# **RECALL CAMPAIGN BULLETIN**

#### NTB16-054b

# VOLUNTARY SAFETY RECALL CAMPAIGN OCCUPANT CLASSIFICATION SYSTEM CONTROL UNIT REPLACEMENT

This bulletin has been amended to add an alternative method for performing zero point reset using BOSCH MTS 6513. No other changes were made. Please discard previous versions of this bulletin.

#### Front Passenger Air Bag Status Light

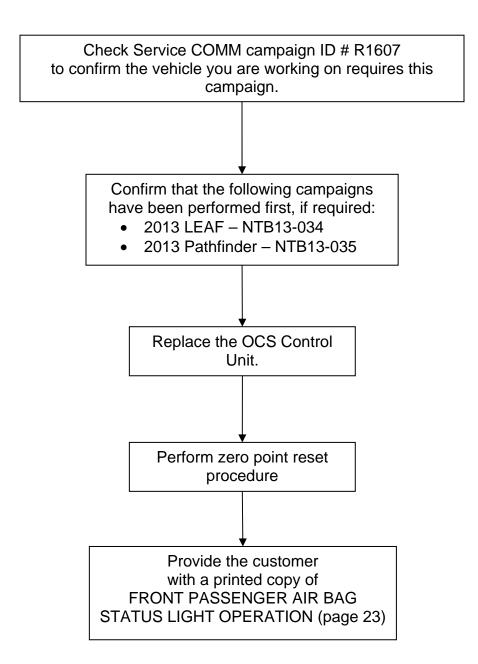
Performing the procedures in this bulletin (campaign R1607) changes the operation of the passenger air bag status light.

• After performing this campaign, the passenger air bag status light will be ON (illuminated) when the front passenger seat is empty.
